**DANE COUNTY DEPT. OF
PUBLIC WORKS, HIGHWAY &
TRANSPORTATION**

ADDENDUM

RFB NO. 317035 - ADDENDUM NO. 1

COLISEUM PERFORMANCE AREA LIGHTING & RIGGING UPGRADES

Installation Requirements: Results assume ± 3% nominal voltage at line side of the driver and structures located within 3 feet (1m) of design locations.

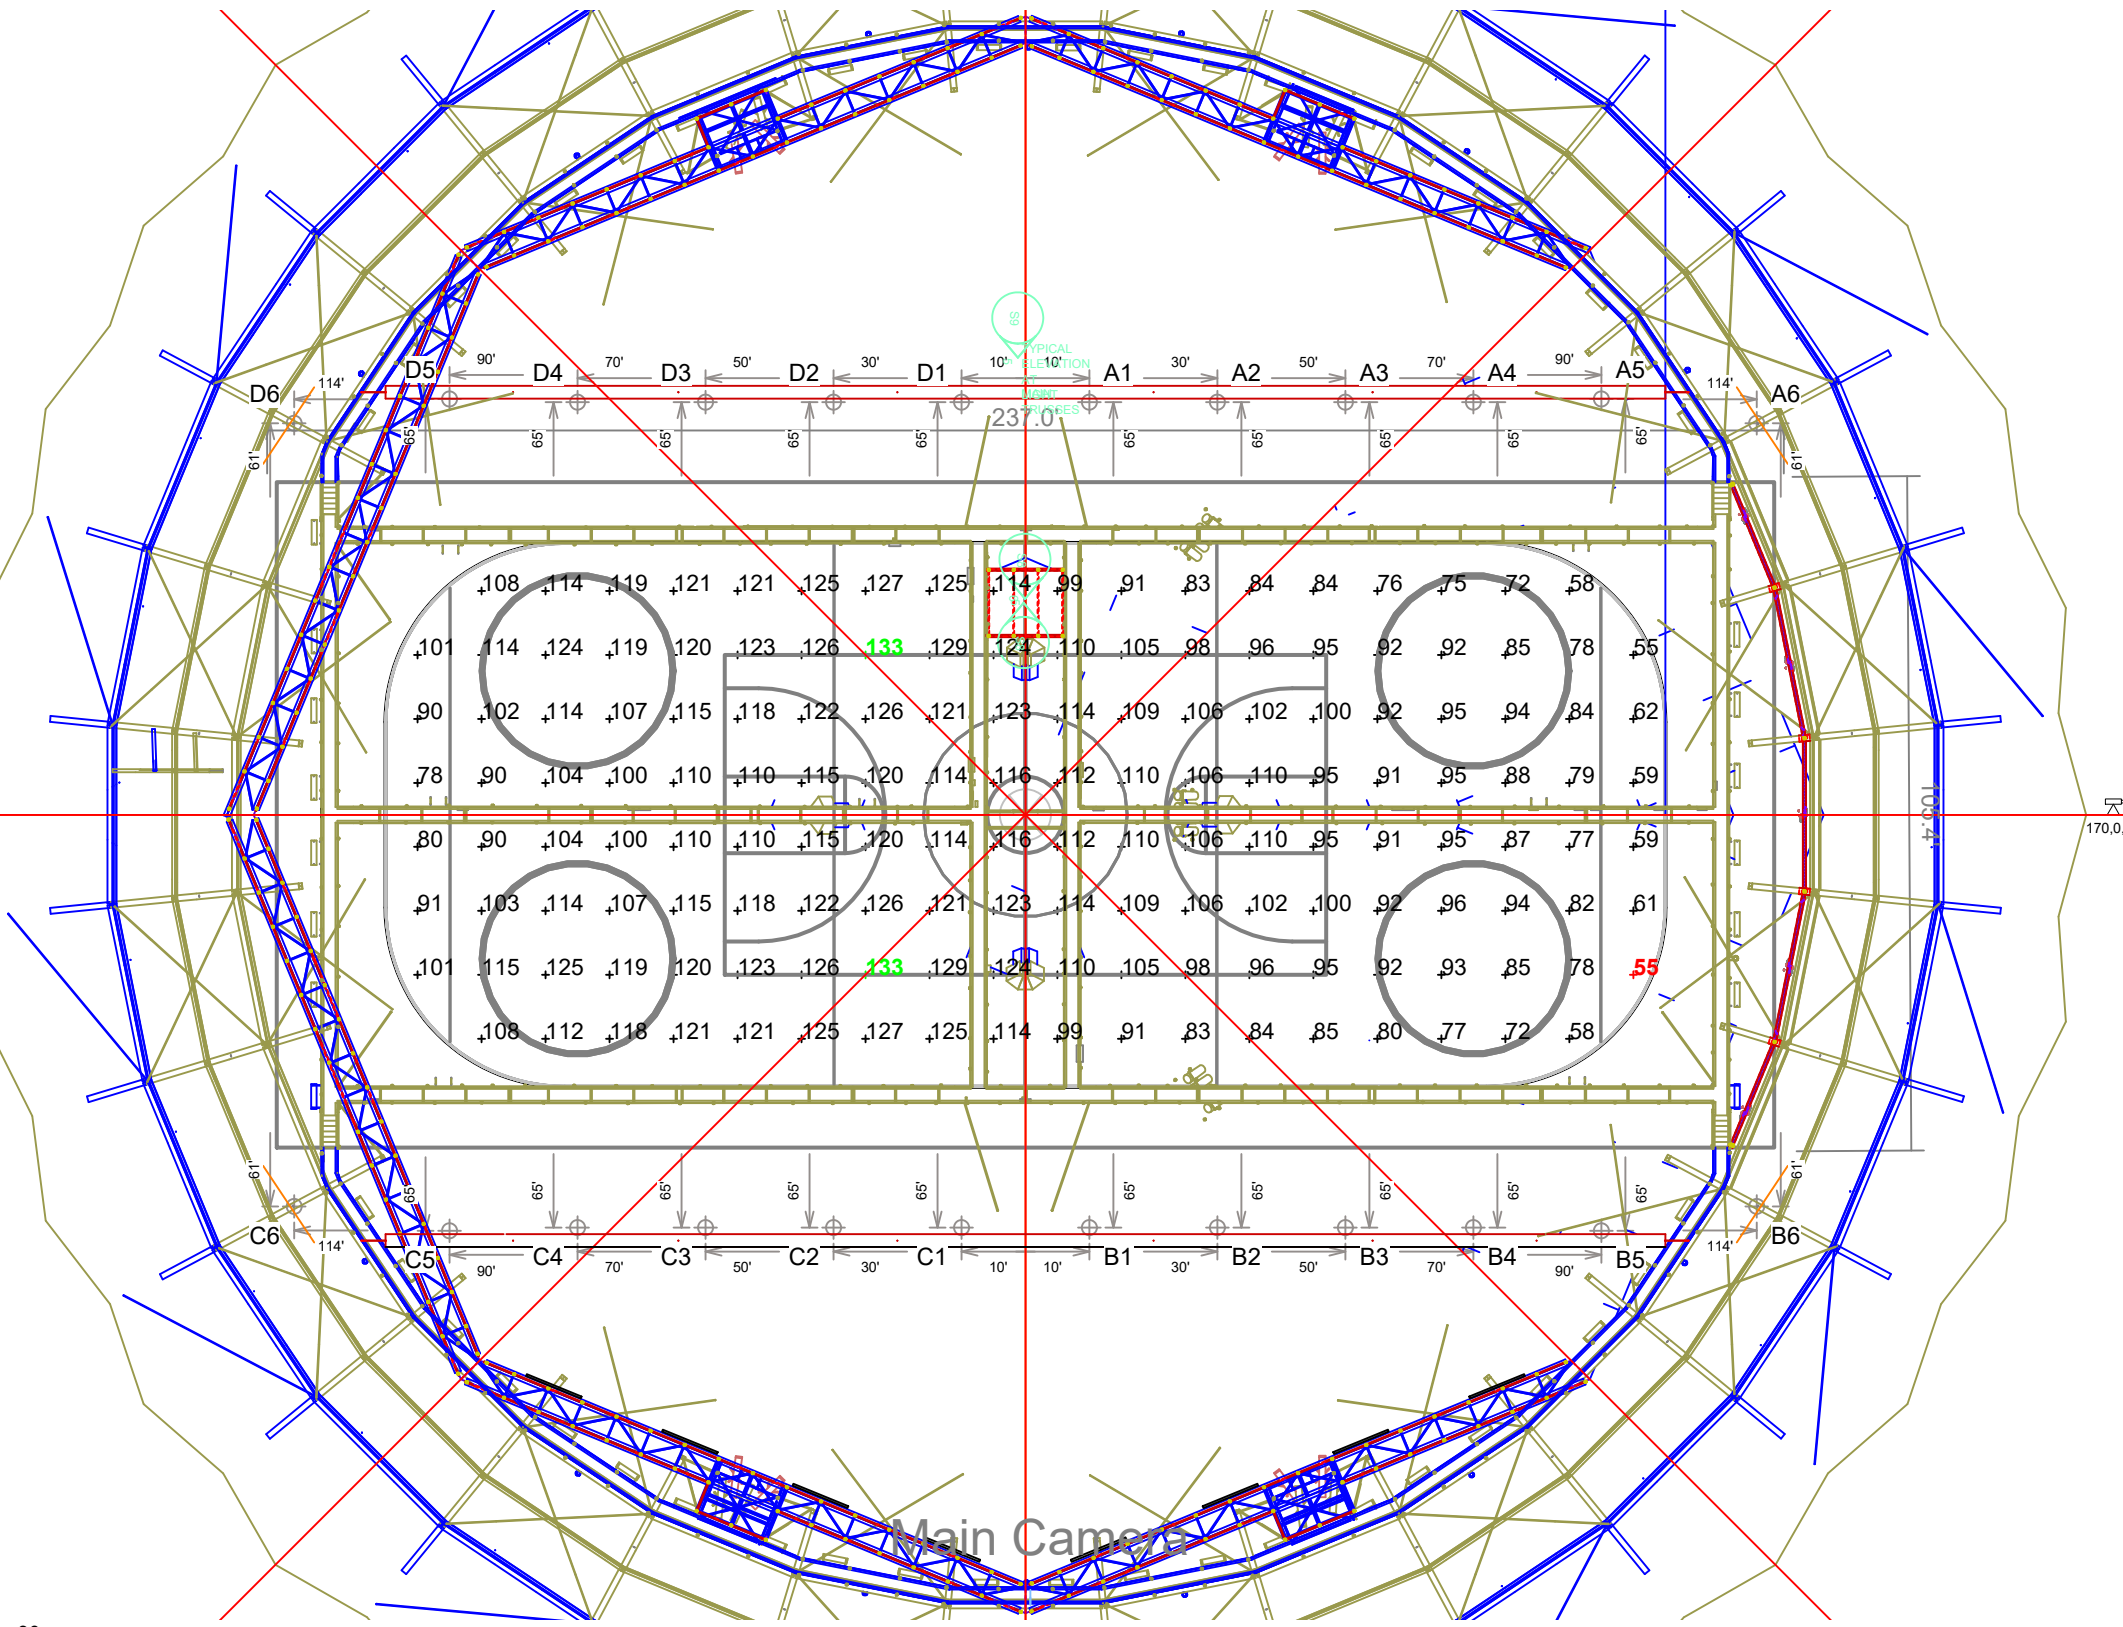
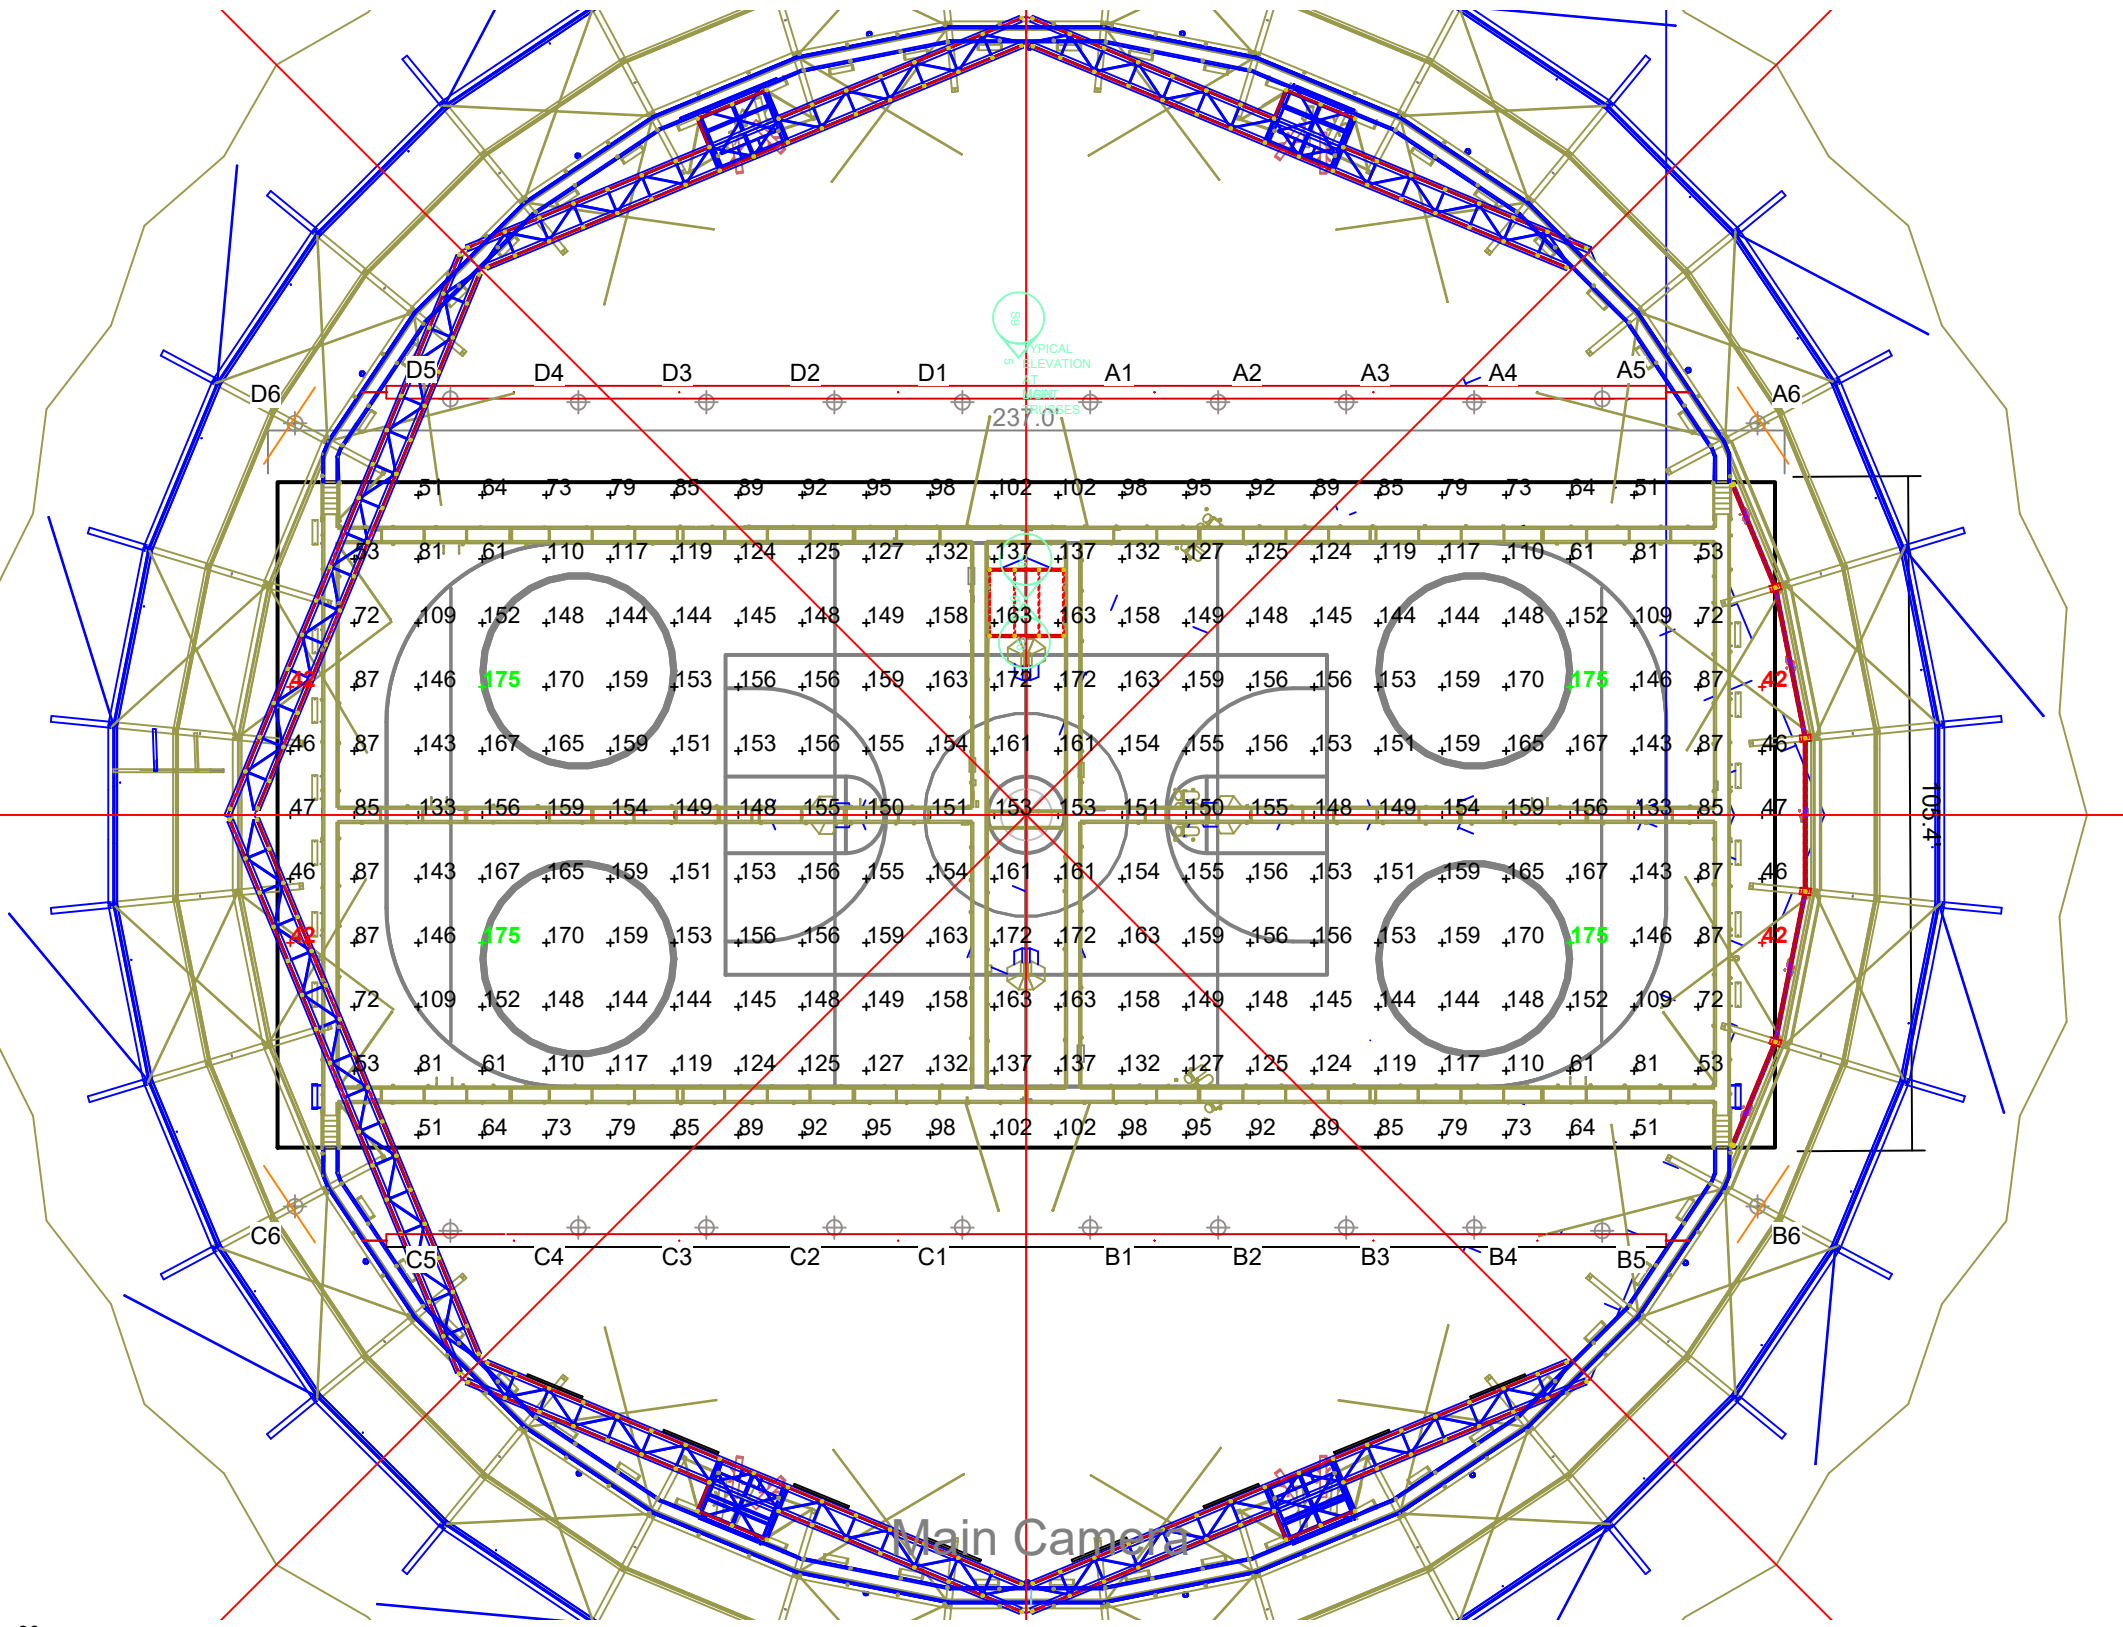
Delete current Exhibit 1; replace with new Exhibit 1, issued with this Addendum.
